APPLICATION NO.	FILING DATE	FIRST NAMED INVENTOR	ATTORNEY DOCKET NO.	CONFIRMATION NO.
10/761,144	01/20/2004	Martin Czech	Micronas.7397	1555

Office Action Summary

DETAILED ACTION

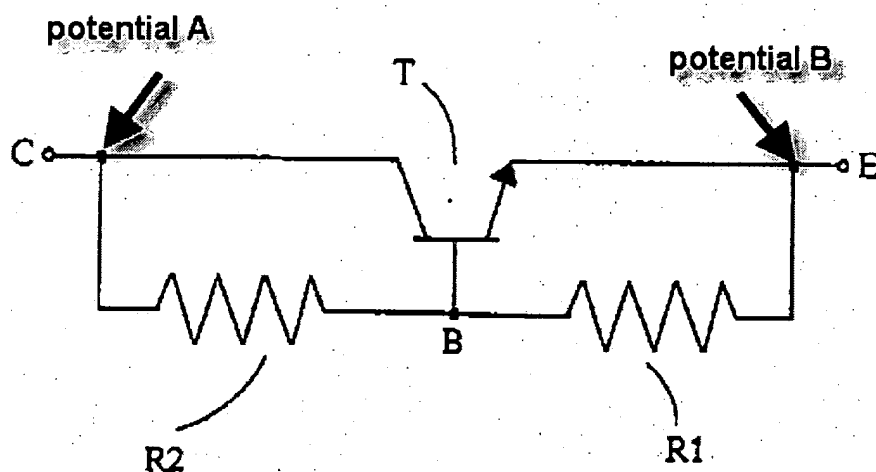
However, Scaccianoce discloses the base (B) of transistor (T) is connected through a resistance (R1,R2) to the potentials (A,B), and the collector and emitter of transistor are connected directly to one of the potentials (A,B). (Note see fig below, and fig. 1 of Scaccianoce).
